Blumel Hall

Re-pipe & Remodel

PORTLAND STATE UNIVERSITY

Revisions :	Date :
1 5 / 4 / 12 ADDENDUM #1	4/17/12

1. See specification sheet for notes. A
2. See Finish Schedule for finish notes. PT

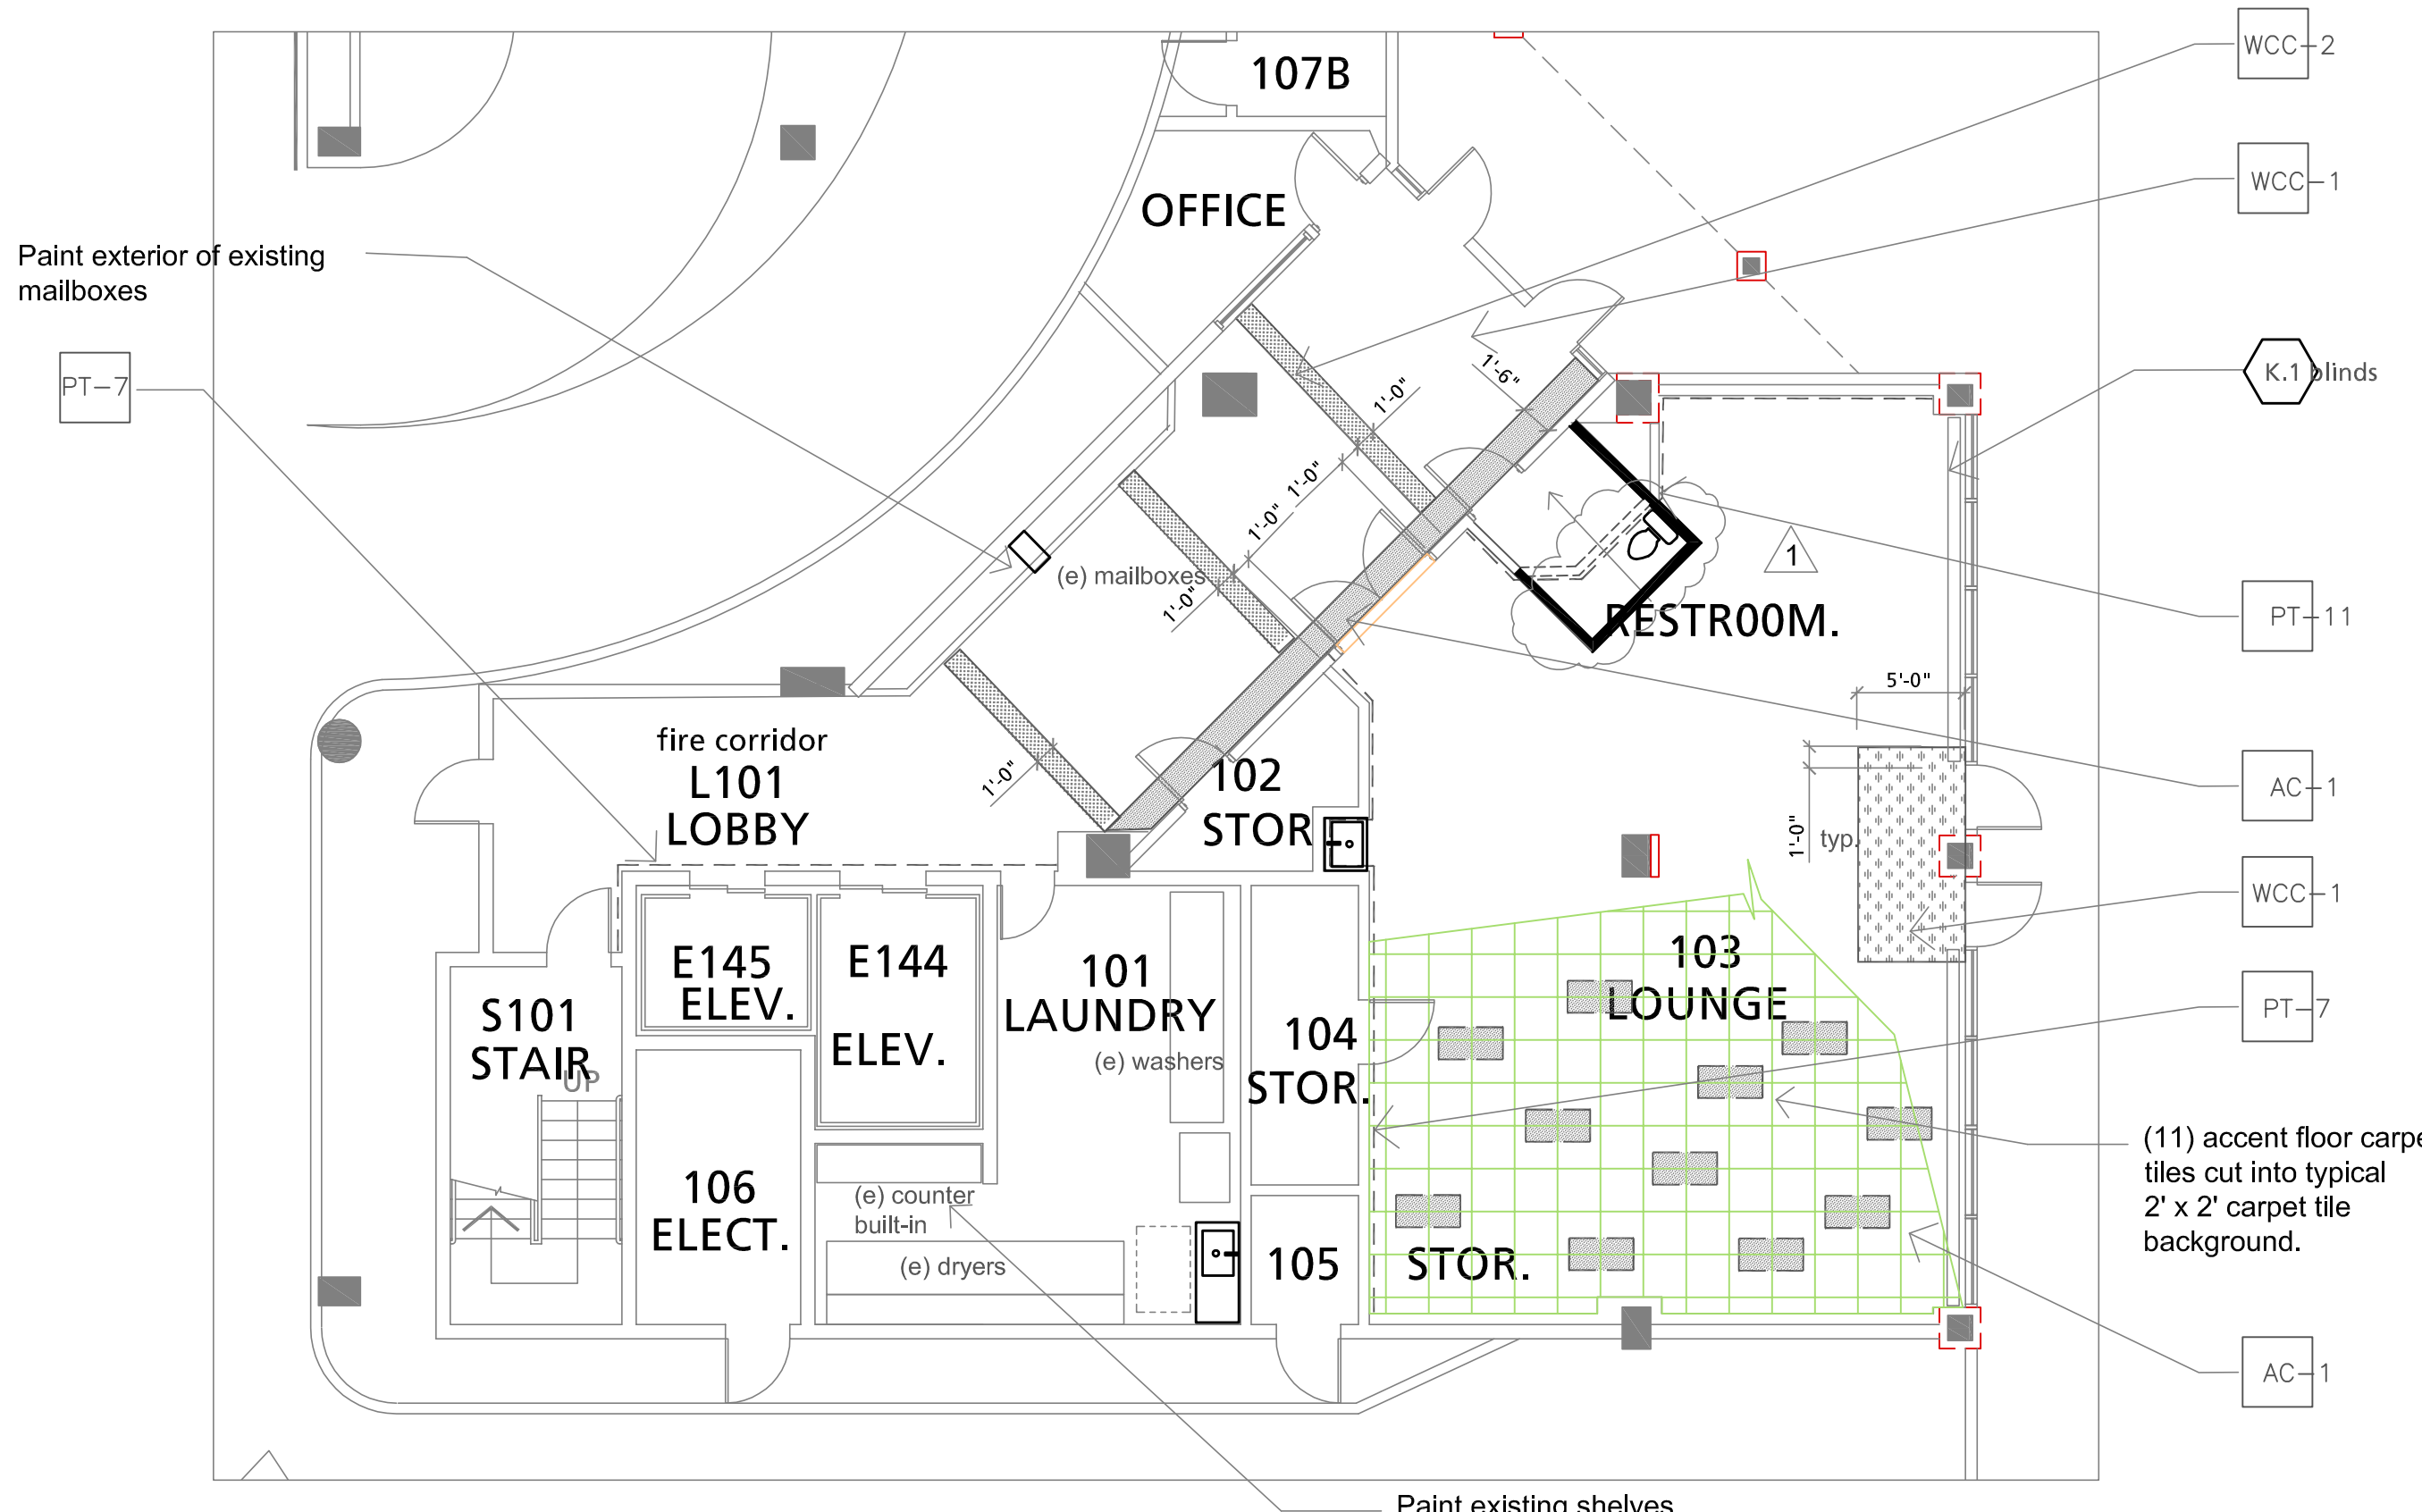
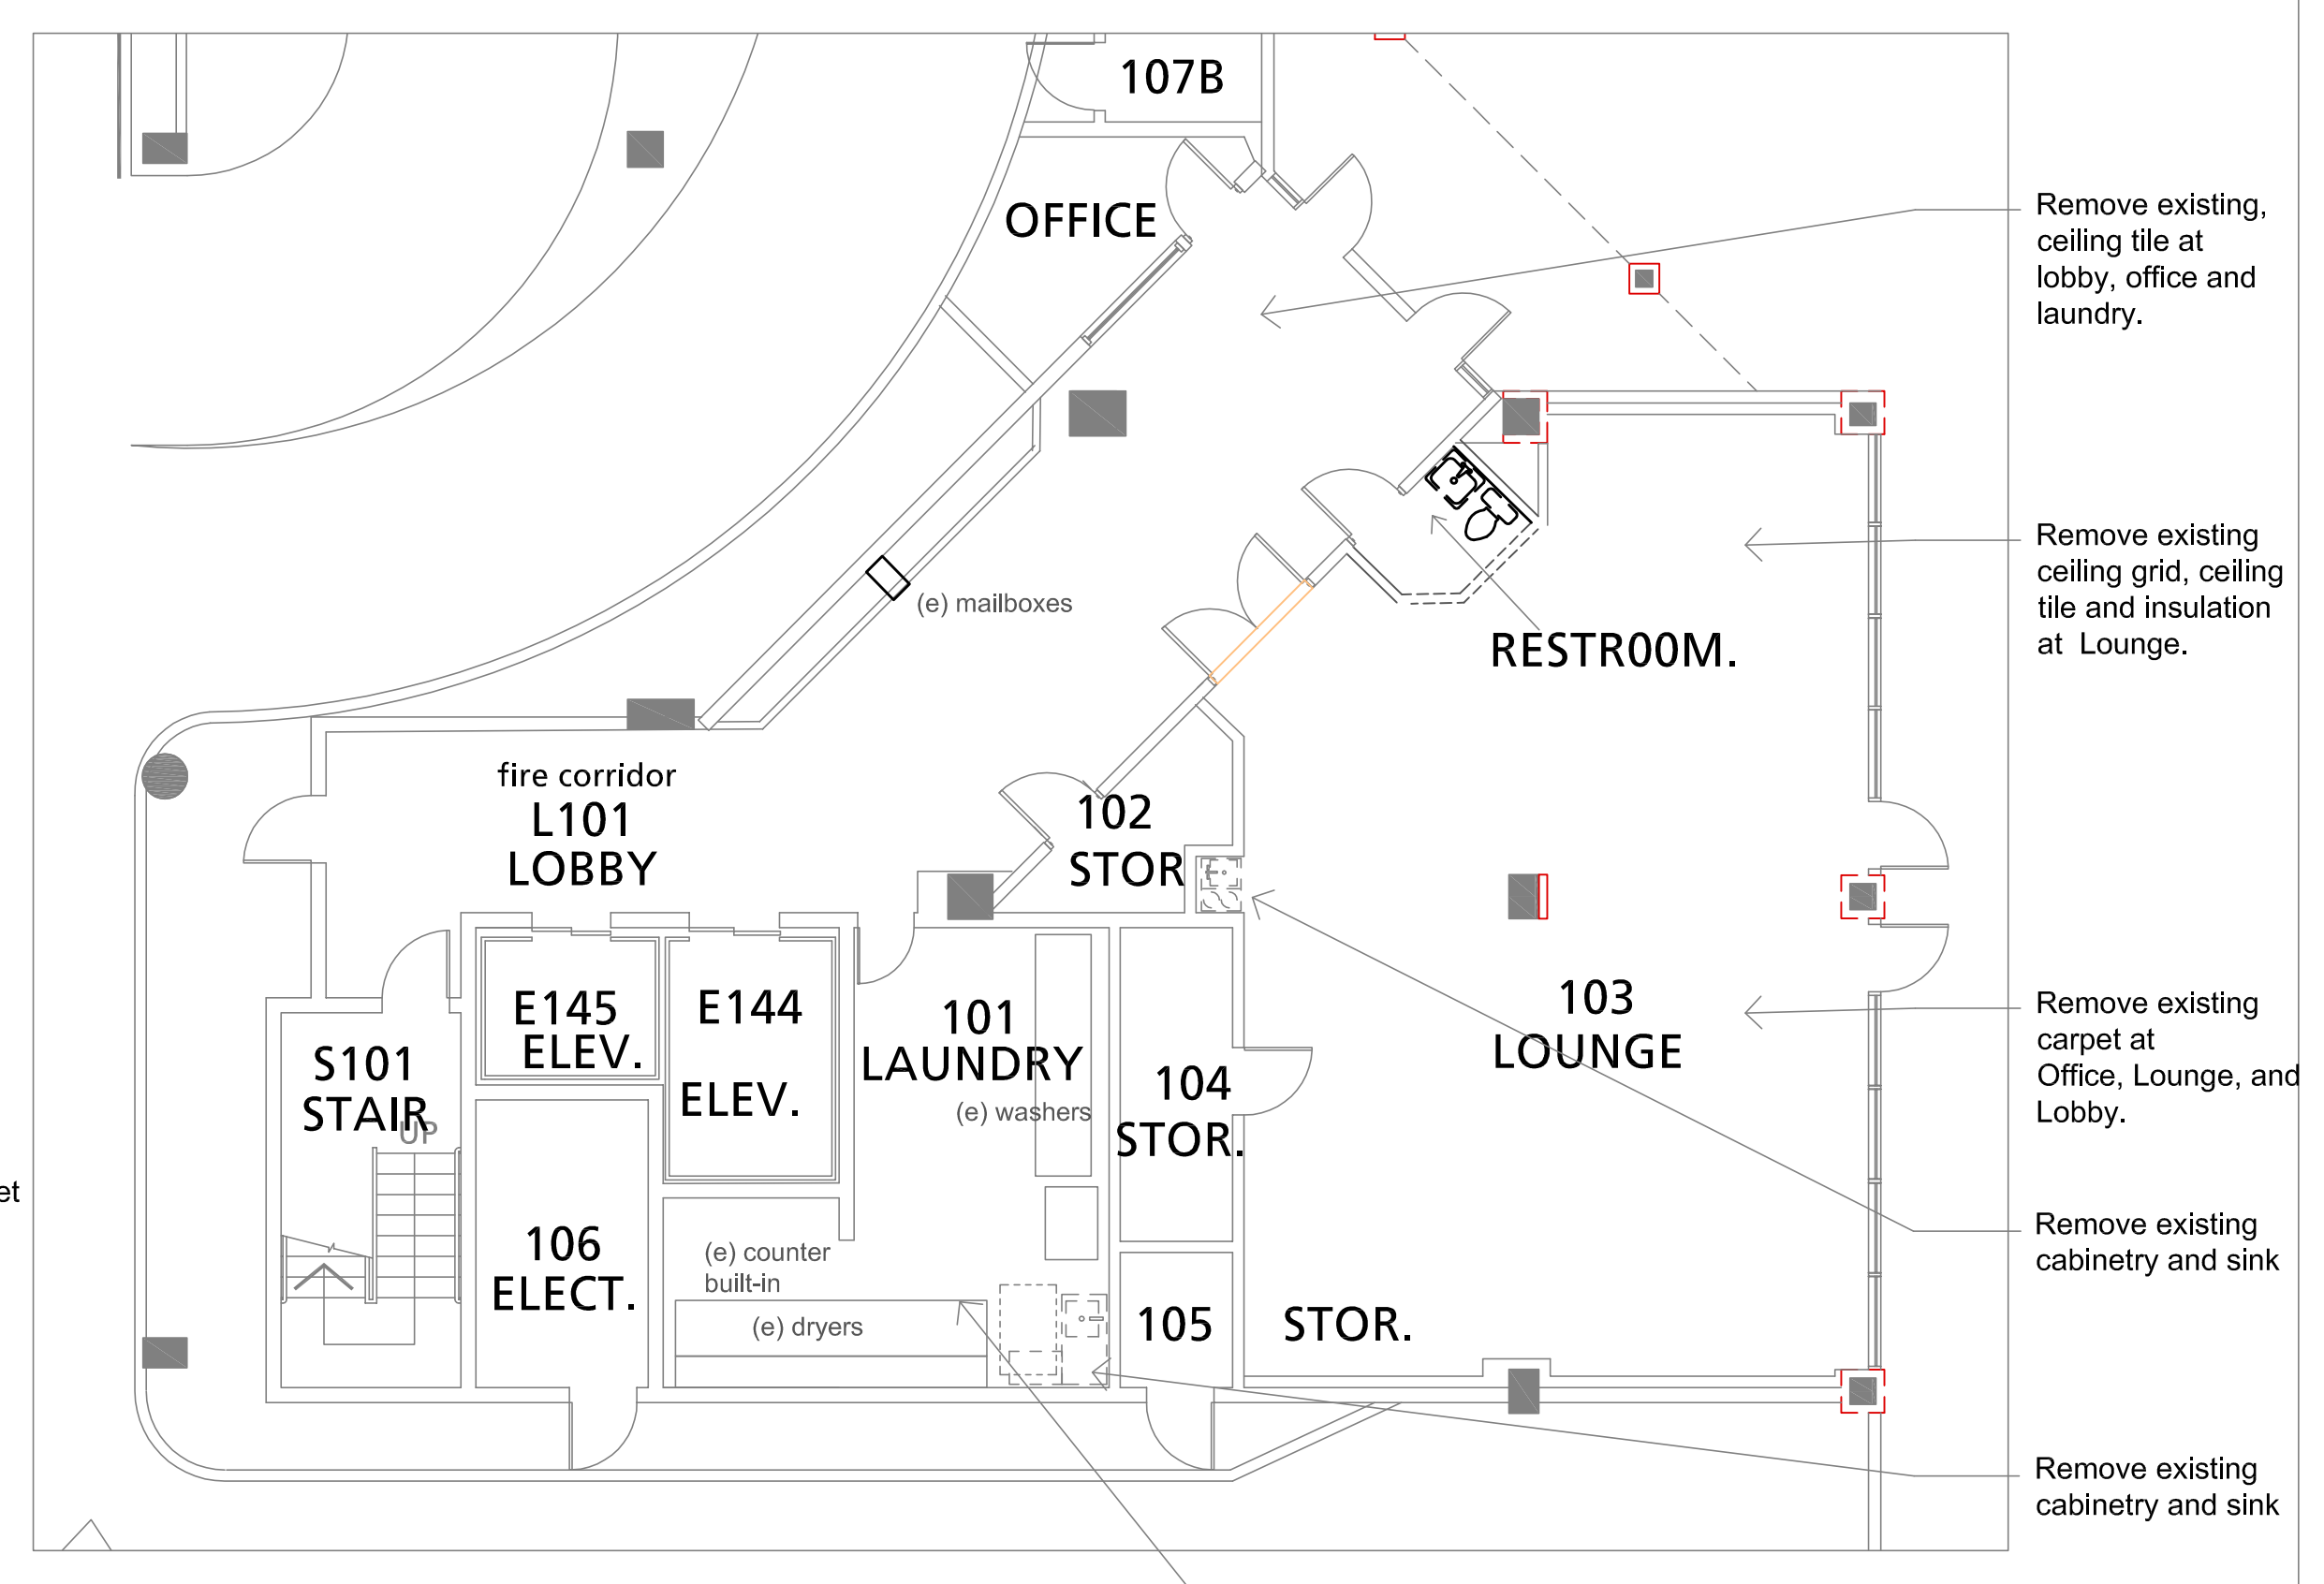
1. See specification sheet for notes.
2. Prior to paint stripping removal, inventory parking stall layout and total spaces. Replicate layout and number of spaces, with the exception of the accessible parking and minimum drive aisle areas.

A7.7

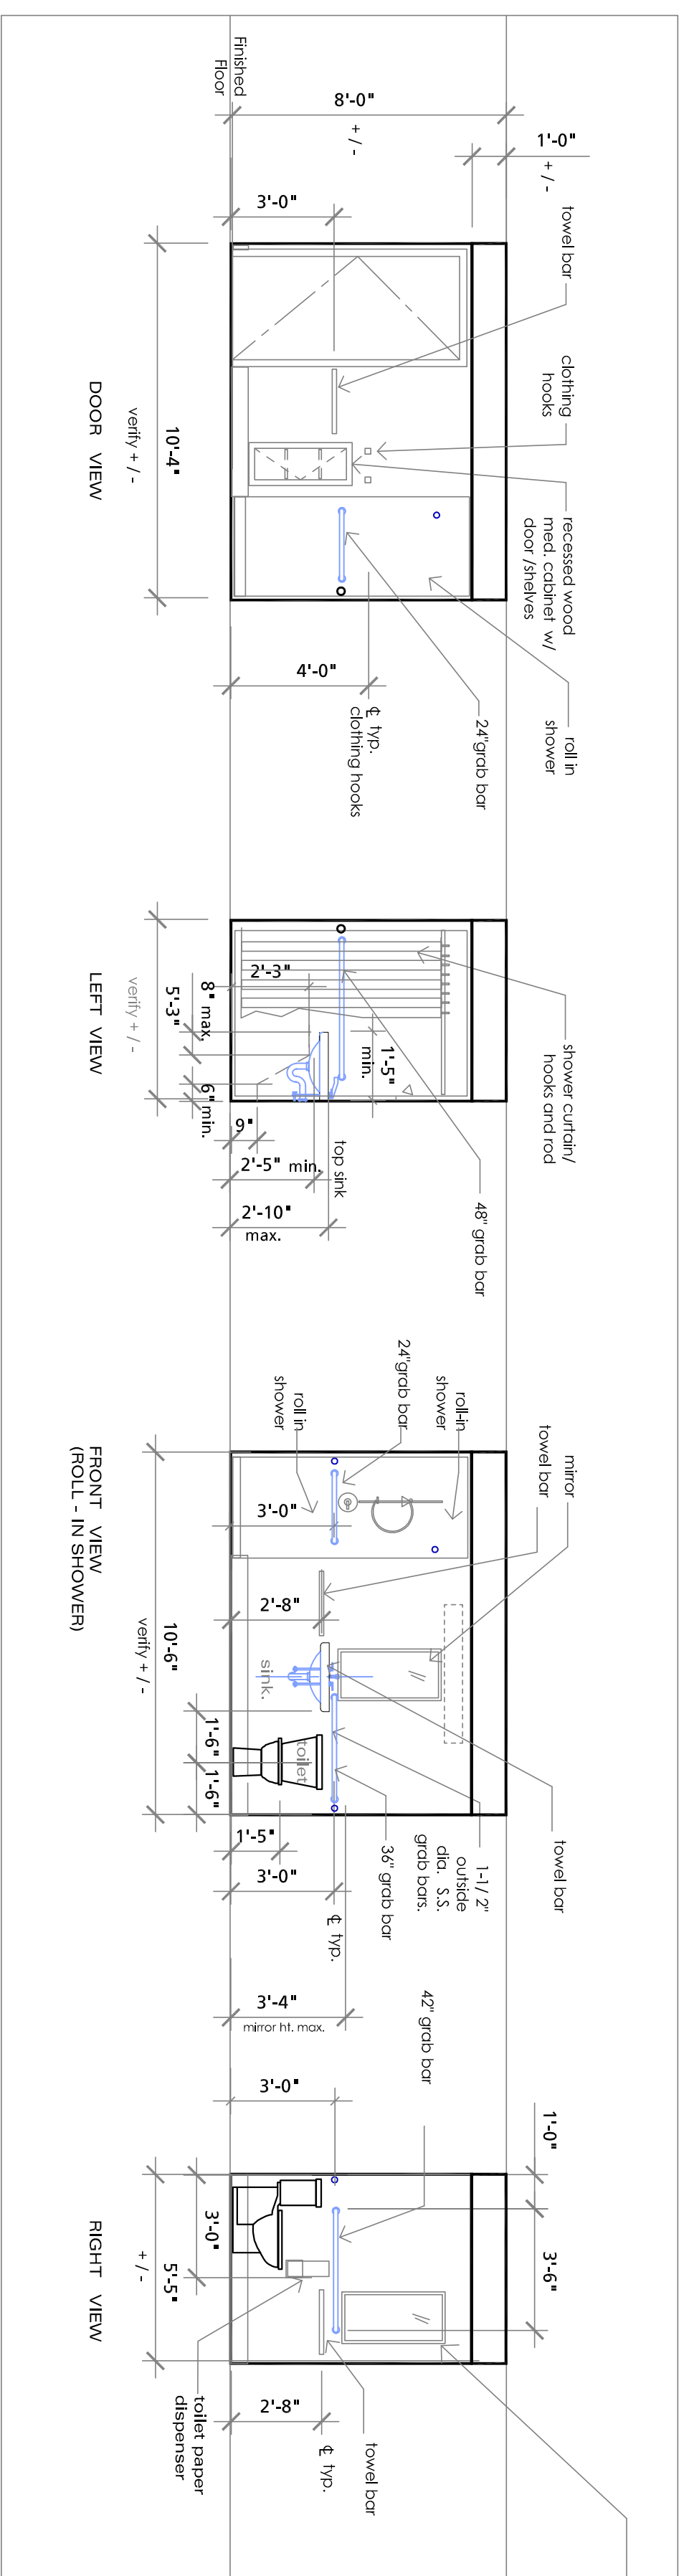
ABI # 11
